Access Compliance Report

Public Rights-of-Way

(Curb Ramps)

Intersection ID: 50449	Main Street: MAGNOLIA_WOODS_LN	Cross Street: MARLEY_WALK_LN	Location: SE
ADA ID: F633FC416397	Ramp Type: PerpDiag	Initial Pass/Fail: Fail	Overall Compliance: No
Severity Score: 13.75			
Codes/Mitigation Info/Possible Solution		Field Measurements/Component Compliance

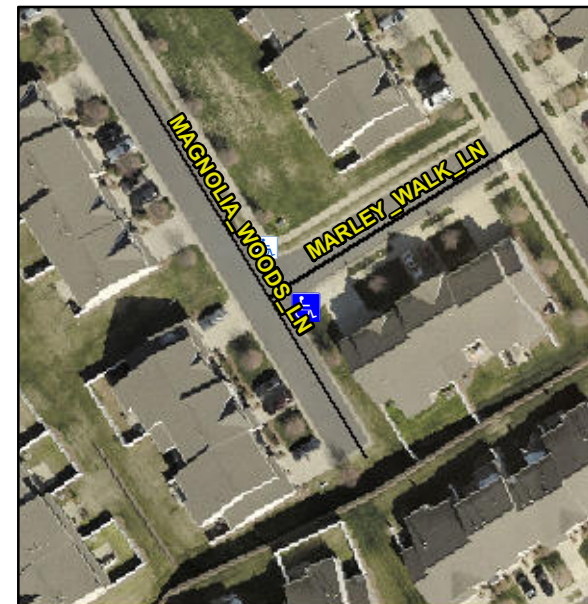
Not Found, R304.2.2, R304.5.3

Compliance	Description	Data	Compliance	Description	Data
N/A	Ramp Length (in)	95.0	No	Ramp Slope (%)	8.6
Yes	Ramp Width (in)	48.0	No	Ramp XSlope (%)	3.0
N/A	Flare Type LT	N/A	N/A	Flare Type RT	N/A
N/A	Flare Slope LT (%)	N/A	N/A	Flare Slope RT (%)	N/A
N/A	Flare Traversable LT?	N/A	N/A	Flare Traversable RT?	N/A
N/A	Landing Length (in)	N/A	N/A	DWS Provided?	N/A
N/A	Landing Width (in)	N/A	N/A	DWS Contrast?	N/A
N/A	Landing Slope (%)	N/A	N/A	DWS Length (in)	N/A
N/A	Landing X Slope (%)	N/A	N/A	DWS Full Width?	N/A
N/A	Landing Curb? (Y/N)	N/A	N/A	DWS Offset (in)	N/A
N/A	Shared Landing?	N/A			
N/A	Gutter Ponding?	N/A	N/A	Gutter Slope (%)	N/A
N/A	Gutter Lip Ht (in)	N/A	N/A	Gutter X Slope (%)	N/A
N/A	Painted X Walk1?	No	N/A	Painted X Walk2?	No
	X Walk 1 Direction	To NW		X Walk 2 Direction	To W
N/A	X Walk 1 Width (in)	N/A	N/A	X Walk 2 Width (in)	N/A
	X Walk 1 Slope (%)	2.4		X Walk 2 Slope (%)	1.0
	X Walk 1 X Slope (%)	0.9		X Walk 2 X Slope (%)	2.2

Remove & Replace Curb Ramp With Two New Directional Ramps or Equivalent.
